**Accessibility Survey**

# City of Downey Cavel Street - Brookshire Avenue to Boyne Street

Date of Inspection 8/30/2017

## City of Downey Cavel Street - Brookshire Avenue To End

#### Tree West Of Brookshire Avenue @ 33.928249948261, -118.137434720993

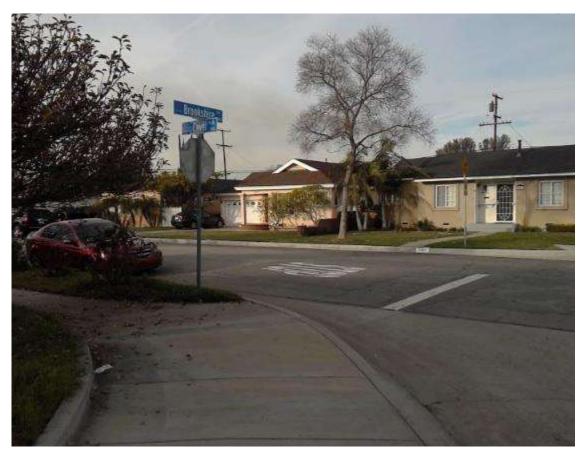
Sidewalks , Hazards & Gratings : Overhead Obstruction Height

Overhead obstruction height is not compliant.

On-Site Finding 70.00 inches

Provide a compliant vertical clearance height.

Recommendation At least 80.00 inches
